On Feb 4, 2021, at 2:05 PM, Gonzalez Nava, Alejandra <AGonzalezNav@saniego.gov> wrote:

Project Manager
City of San Diego
Engineering & Capital Projects Department

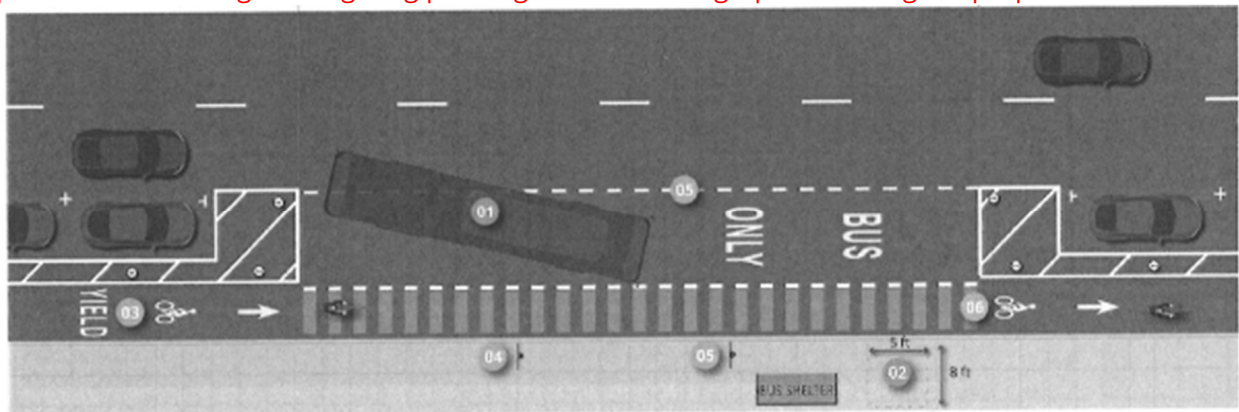
8. How would bus loading platforms work into the road design? Would they be retrofitted after the fact or accommodated during the road widening?

Bus loading platforms are accommodated in the design of the Coastal Rail Trail project by implementing a shared bus stop/bike lane configuration. Transit vehicles are allowed to pull into the stop along the curb, across the separated bike lane. When buses are present, cyclists merge left and pass buses boarding and alighting passengers. See below graphic showing the proposed treatment.
